ADDENDUM NO. 2

**PORTER TOWNSHIP ADMINISTRATION BUILDING
Valparaiso, IN 46341**

This Addendum forms a part of and modifies the Bidding Requirements, Contract Forms, Contract Conditions, the Specifications, and the Drawings dated August 25, 2026 by Gibraltar Design, Inc. Acknowledge receipt of the Addendum in the space provided on the Bid Form. Failure to do so may subject the Bidder to disqualification.

This Addendum consists of Pages ADD 2-1 through 2-2 and attached Addendum No. 2 from Gibraltar Design, Inc. dated September 18, 2026 and consisting of 5 pages, Specification Section 08 14 32 - Stile and Rail Wood Doors, Specification Section 33 46 16 - Outlet Structures for Stormwater Ponds, and 15 drawings.

1 ELECTRICAL LIGHTING FIRST FLOOR CEILING PLAN - SCOPE A
1/8" = 1'-0"

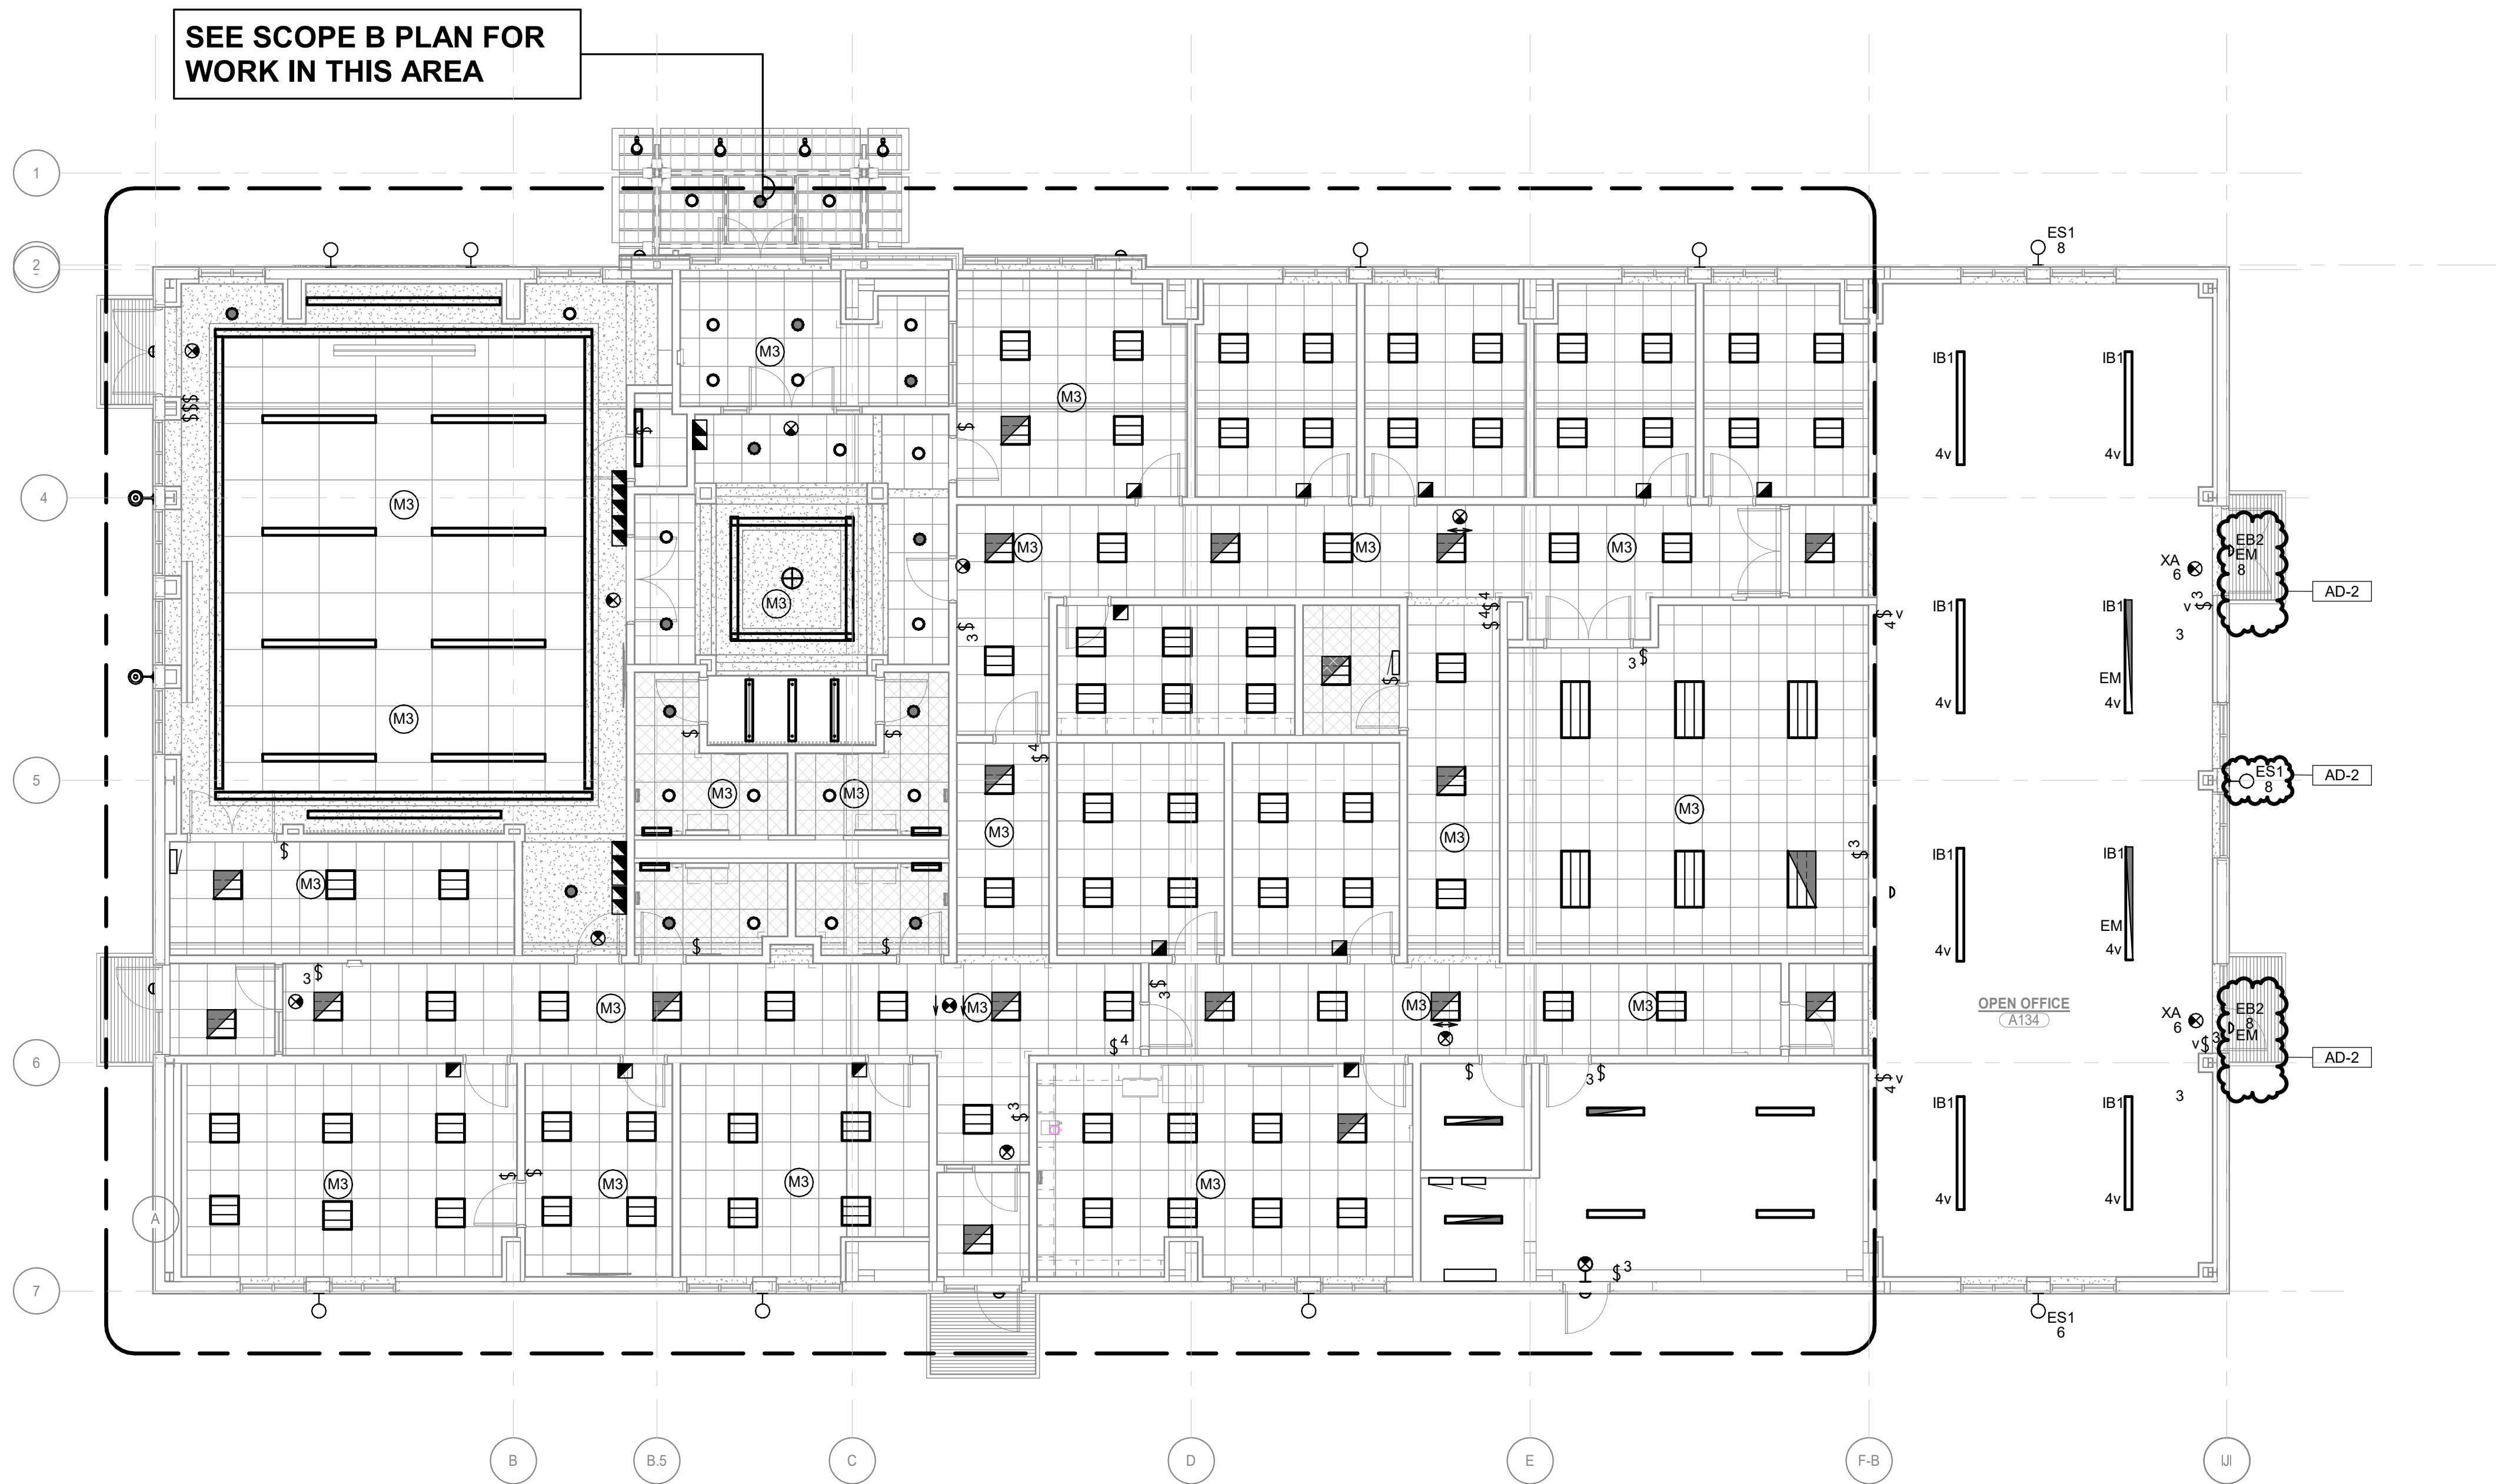
- A. Refer to revised, full-size drawings, included in this Addendum, for revisions.
 - 1. Revised exterior fixture types.
 - 2. Added switches in corridors.
 - 3. Added WB fixture to closet.
 - 4. Revised cove fixture lengths and locations.

TECHNOLOGY FIRST FLOOR PLAN - SCOPE B

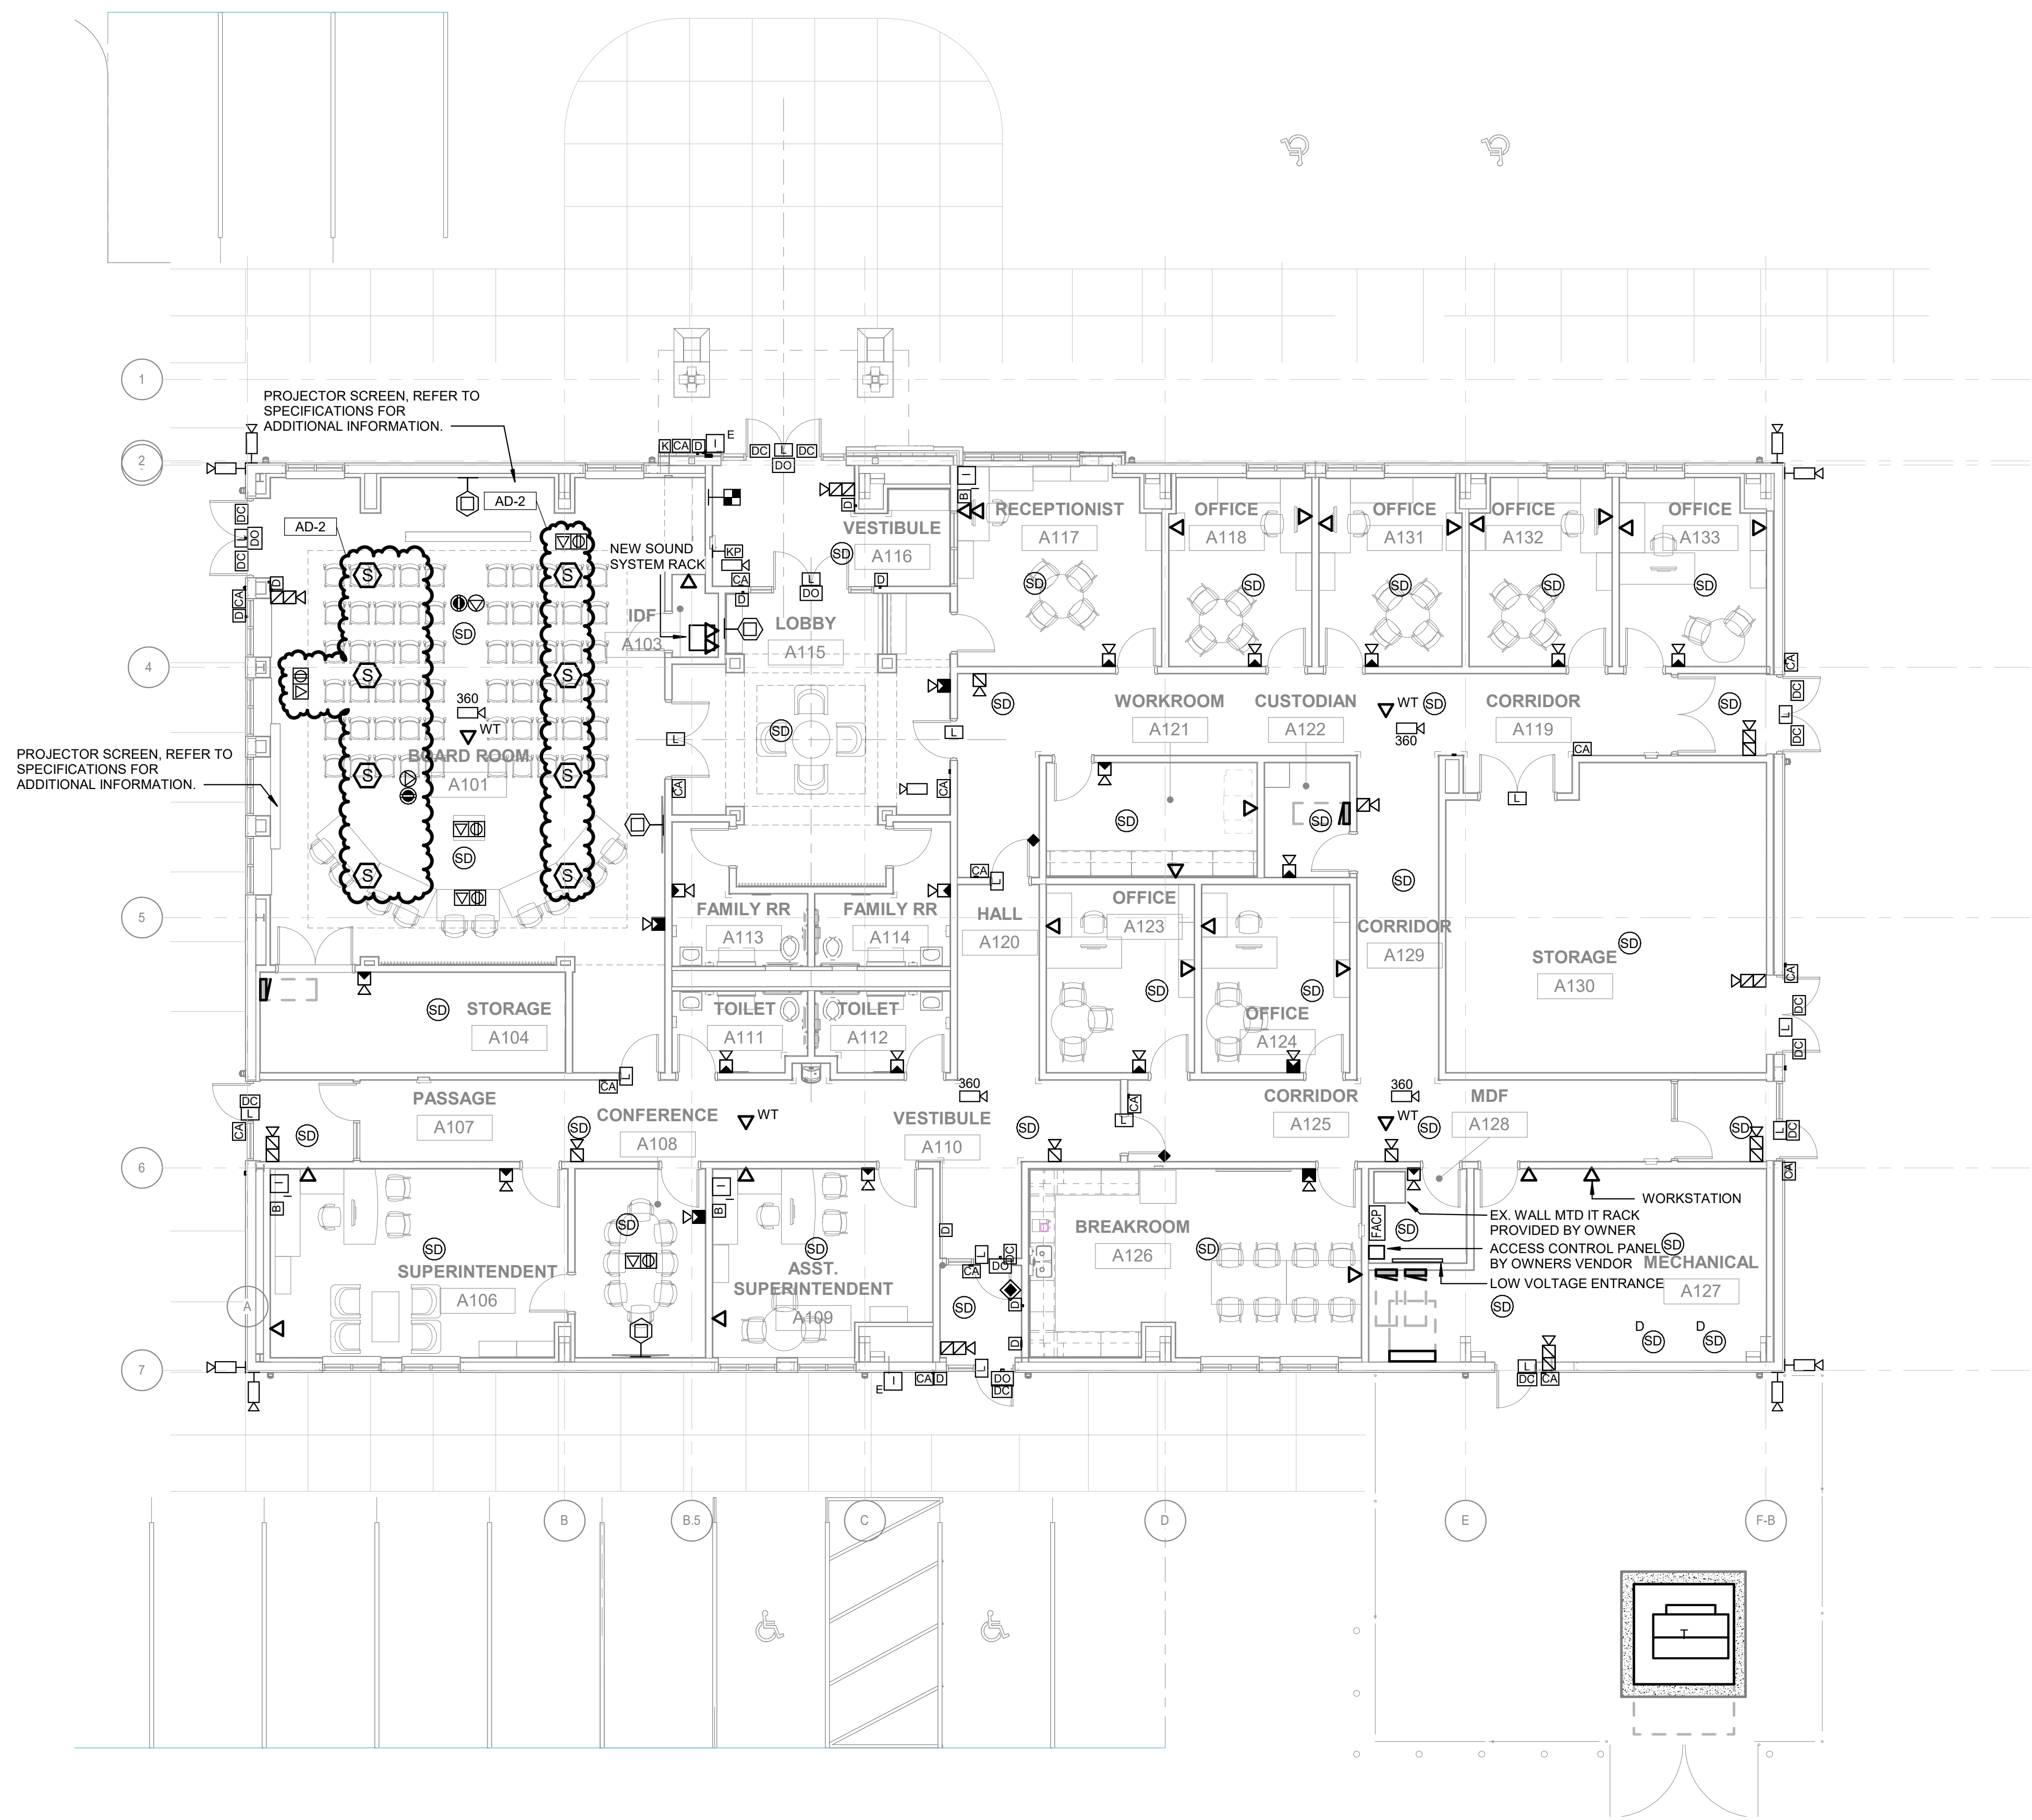
20. Sheet T-101

- A. Refer to revised, full-size drawing, included in this Addendum, for revisions.
 1. Removed ceiling speakers and revised speaker layout.
 2. Moved projector to accommodate new speaker layout.
